SERVICE BULLETIN

APPLICABILITY: 2015-19MY WRX

NUMBER: 12-275-19

SUBJECT: Leather Front Seat Cushion Covers- Loose Fit

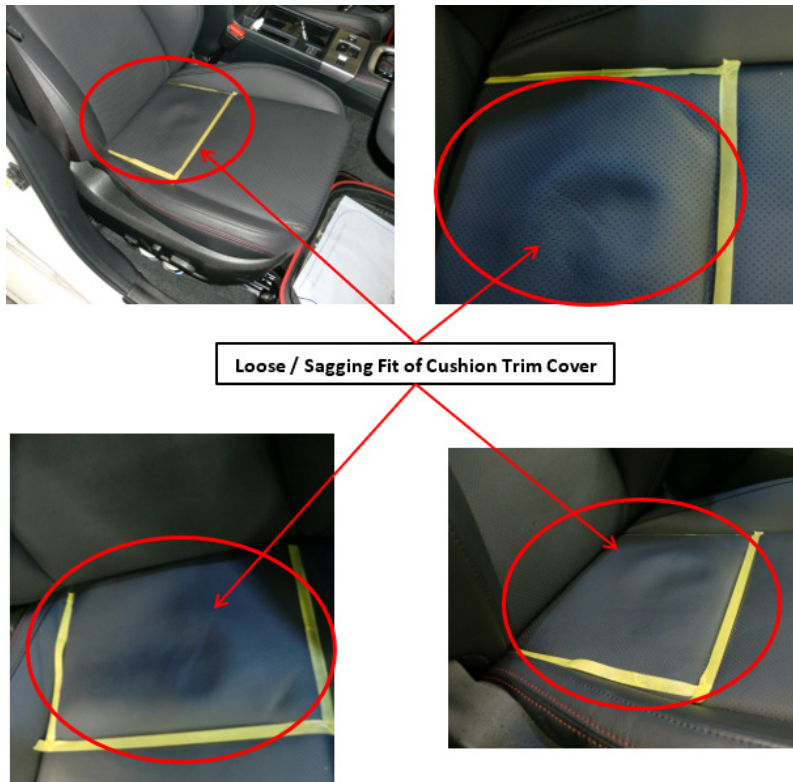
This bulletin announces a change made to the leather front seat cushion covers to address isolated concerns of a sagging / loose fitting condition after an occupant leaves the seat as shown in the example photos below. A pattern revision was made to increase tension of the cover material and decrease the time it takes for the condition to disappear after an occupant leaves the seat.
